Lancaster County
DEVELOPMENT REVIEW COMMITTEE
May 10, 2016
MINUTES

Subject: Redstone Investors OP "C"

DRC 016- 014

RE: DRC 016-014: FIRST SUBMITTAL COMMENTS

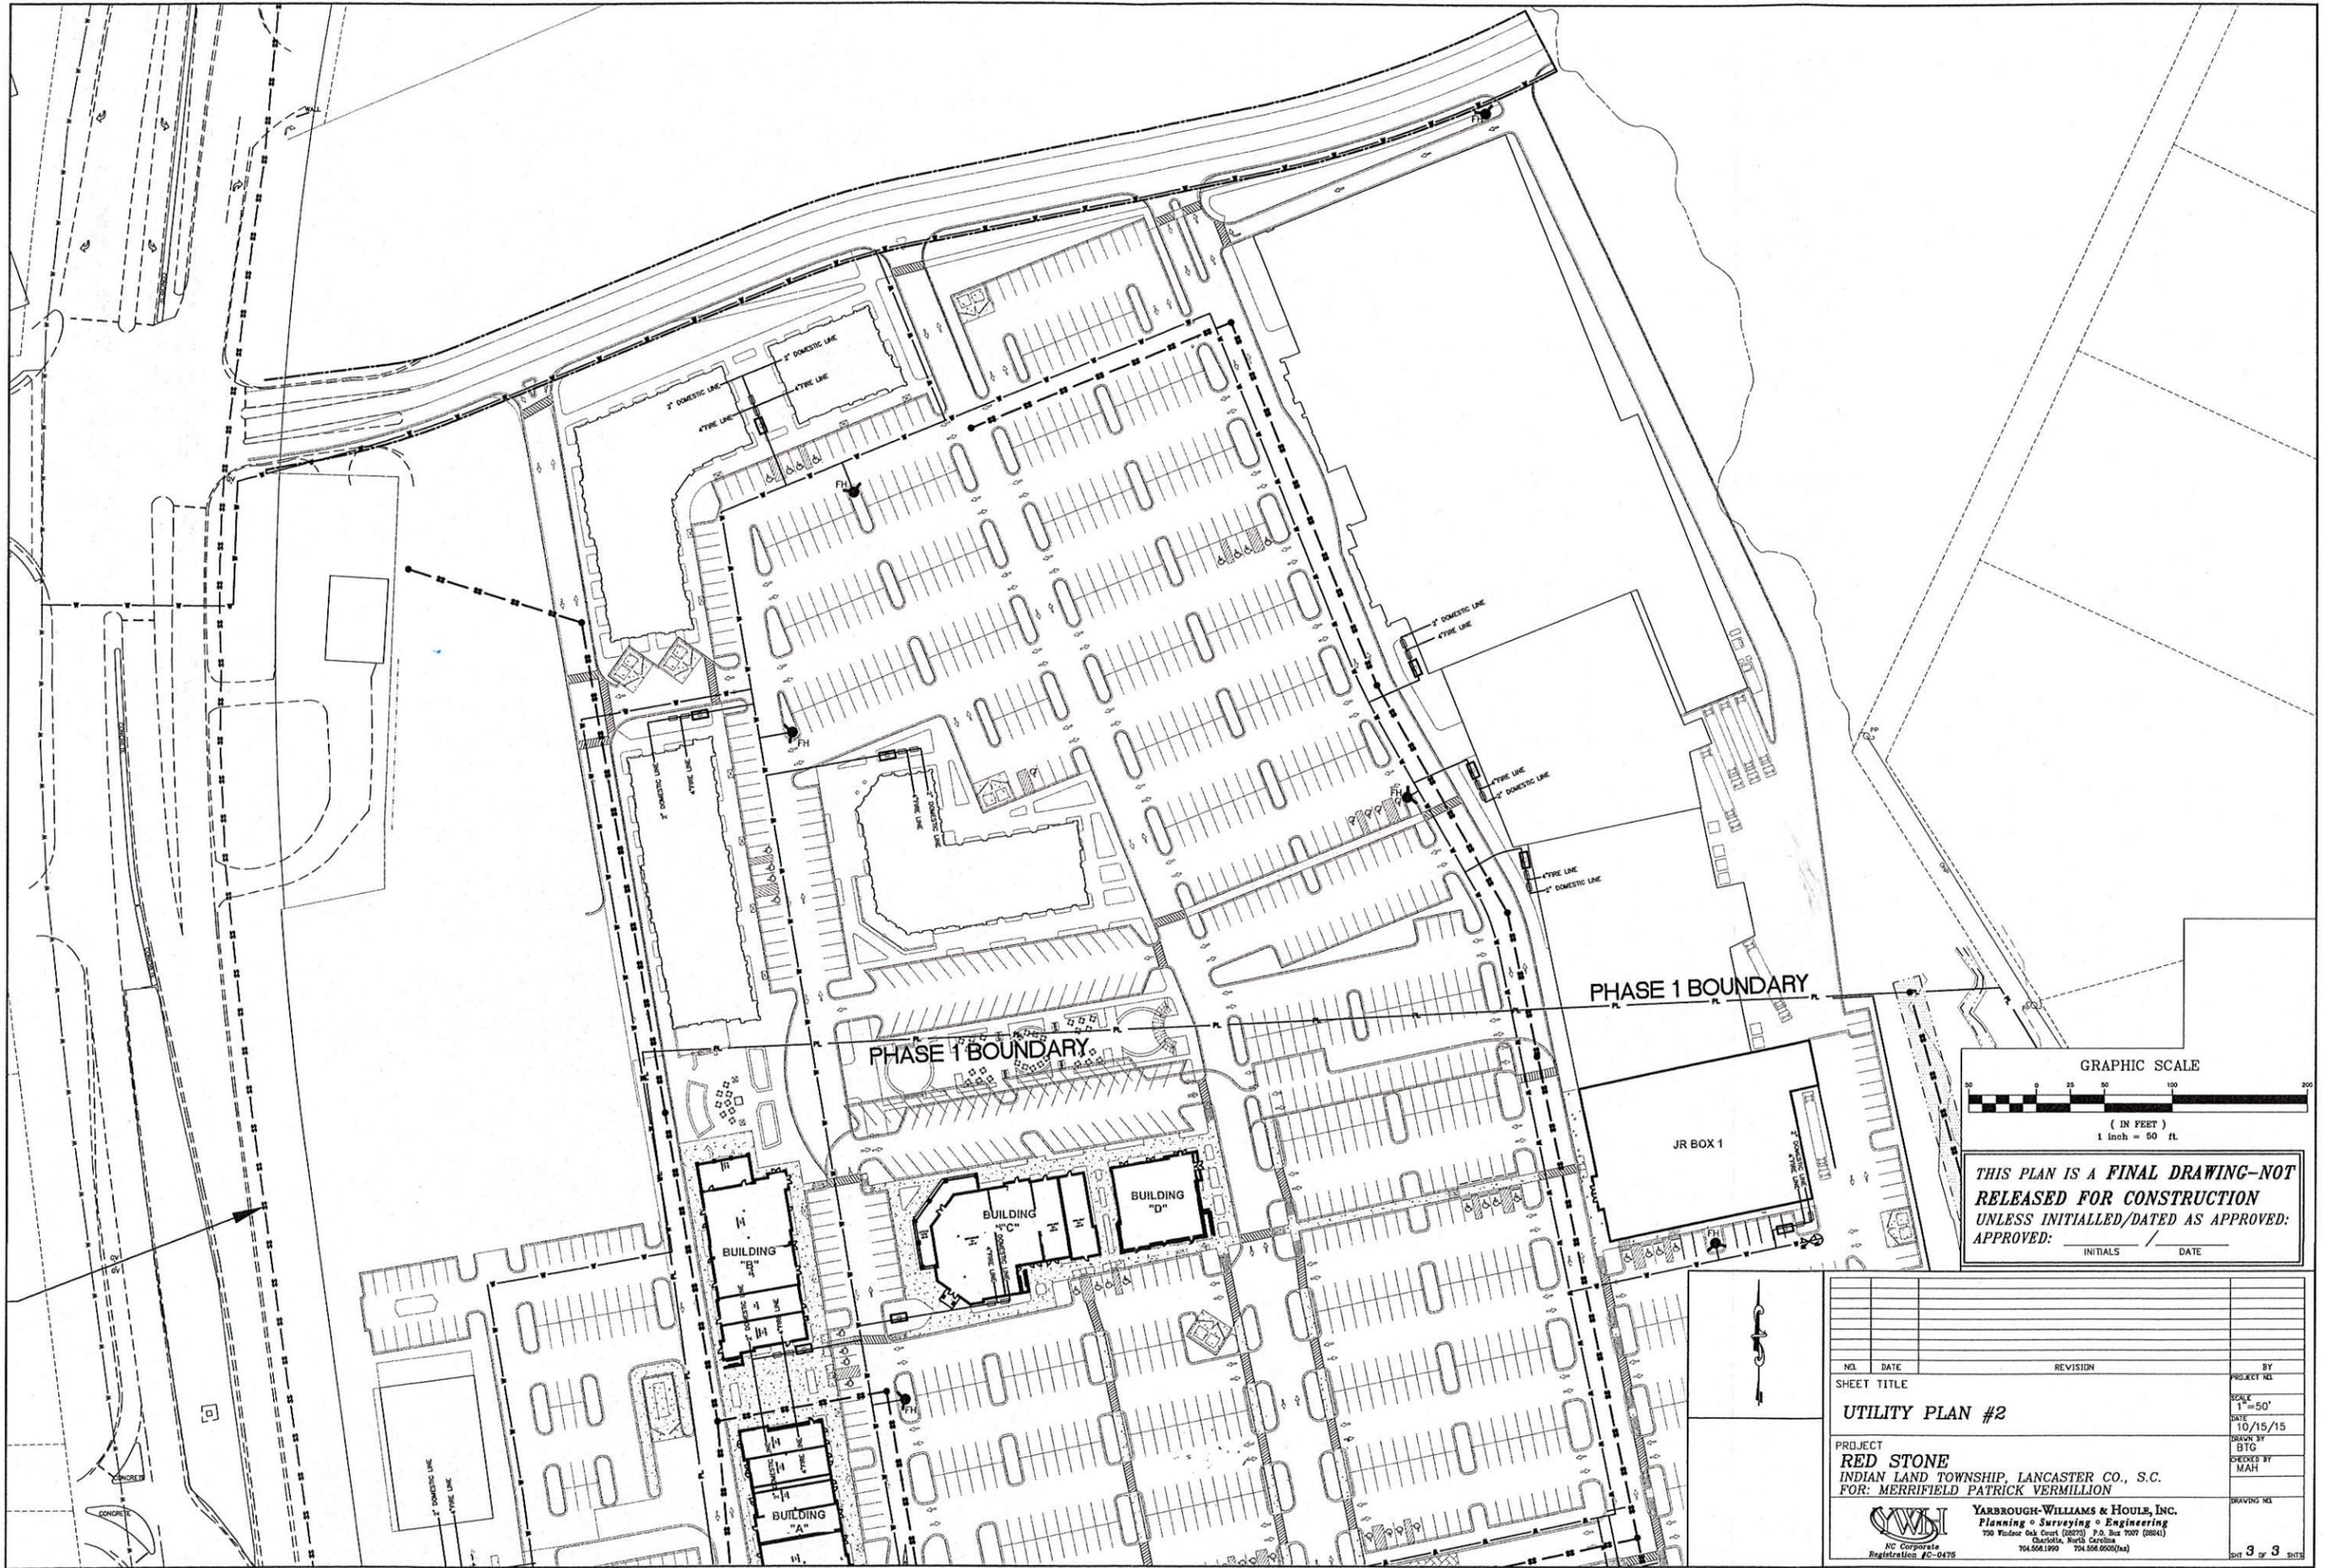
- Good morning. Yesterday (5-10-16) I met with Vince Keene at the DRC meeting for Outparcel C of the Red Stone development. During that meeting, I supplied him with our comments to the site plan you provided last month. Our comments are only on sheet 1 of the plan, and should be incorporated through the Phase 1 and Phase 2 layout of the site. If you have any questions, please feel free to contact us. Thank you.

- As noted above see the attachment from LCWSD (AJM, PLANNING DEPARTMENT)
- As discussed in the DRC meeting, LCWSD can not allow any landscaping to be planted over water and sewer infrastructure (including meters), throughout the site. Also, I checked on the irrigation situation of the Wal-Mart outparcels and each outparcel applied for a separate irrigation meter. You'll need to check with Mike Bilodeau to see if he is proposing to do the same thing at Red Stone. If you have any questions, please let me know. Thank you.

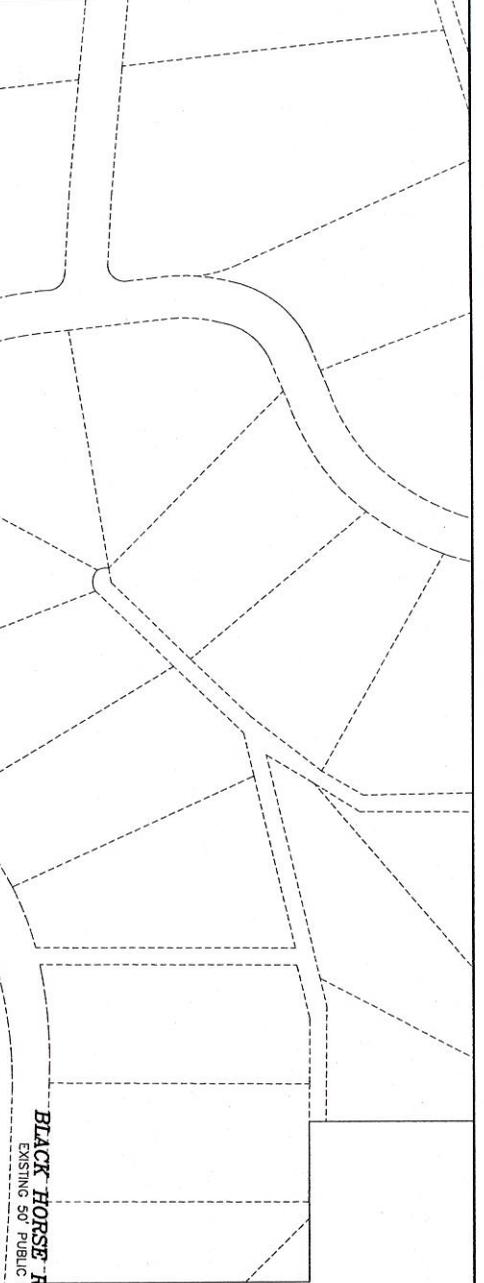
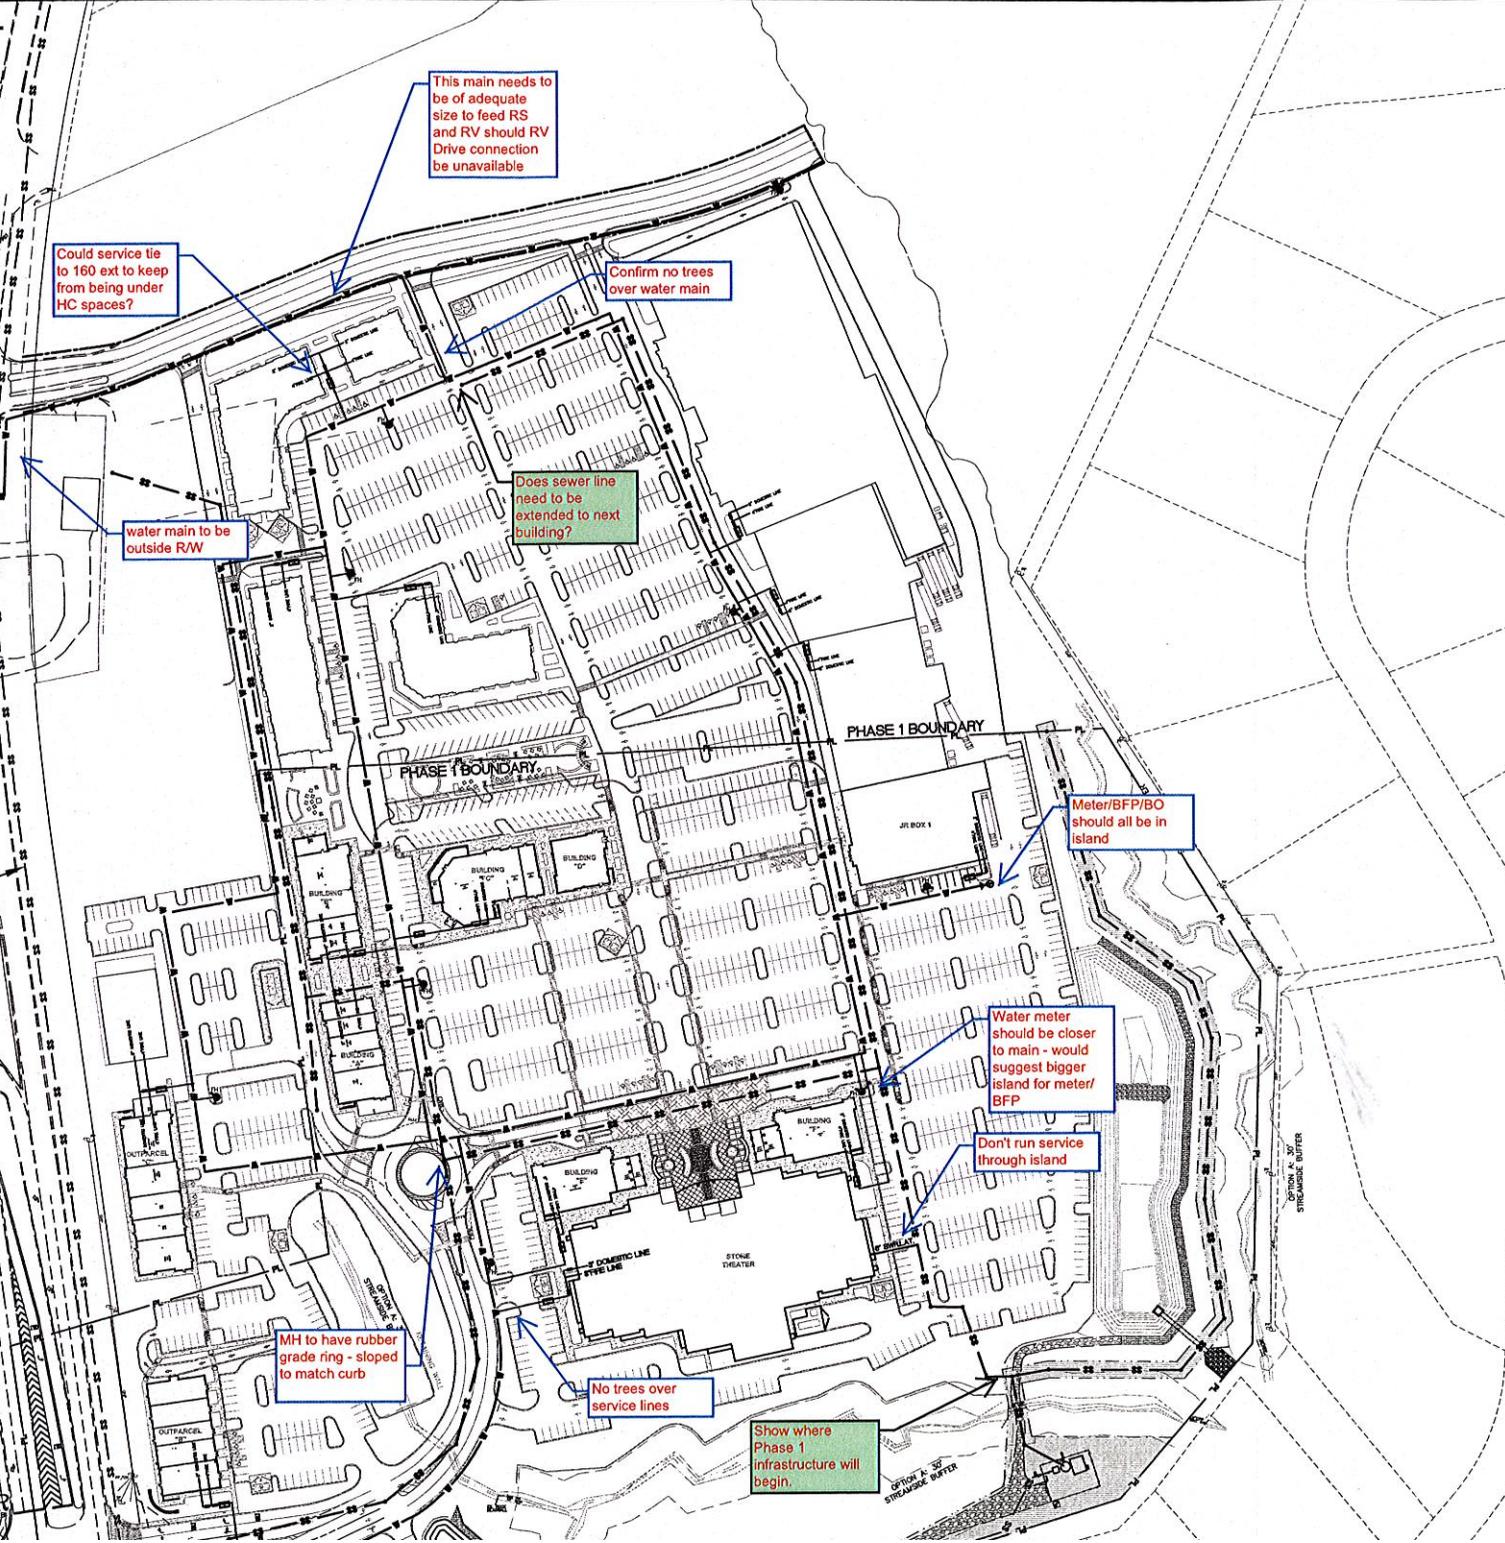
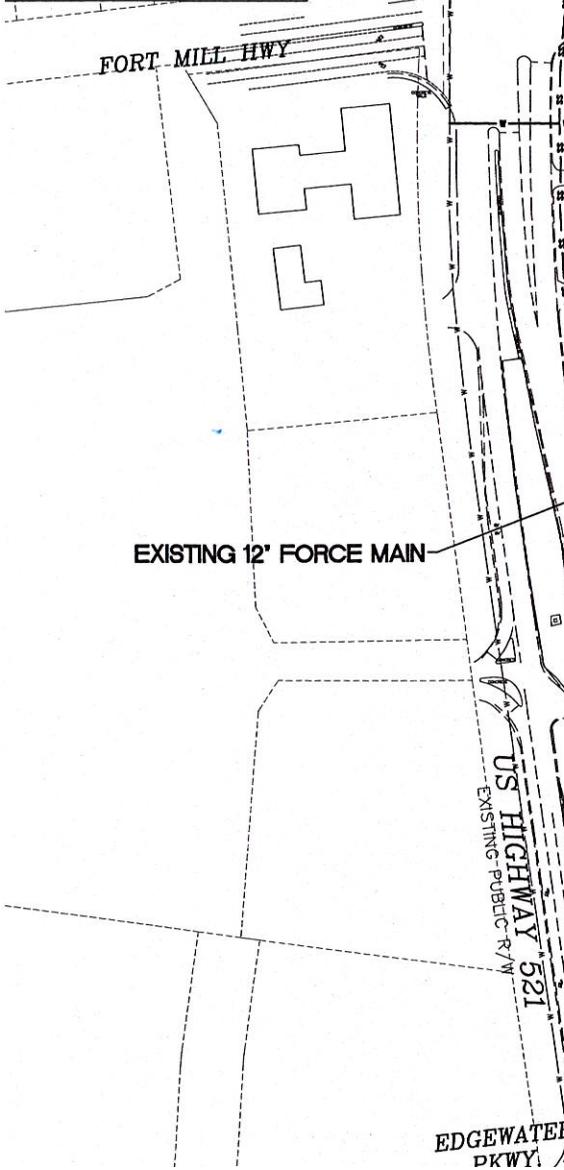
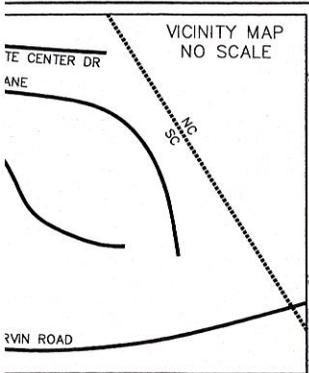
This main needs to be of adequate size to feed RS and RV should RV Drive connection be unavailable

Could service tie to 160 ext to keep from being under HC spaces?

Confirm no trees over water main

water main to be outside R/W

Does sewer line need to be extended to next building?

Meter/BFP/BO should all be in island

Water meter should be closer to main - would suggest bigger island for meter/BFP

Don't run service through island

MH to have rubber grade ring - sloped to match curb

No trees over service lines

Show where Phase 1 infrastructure will begin.
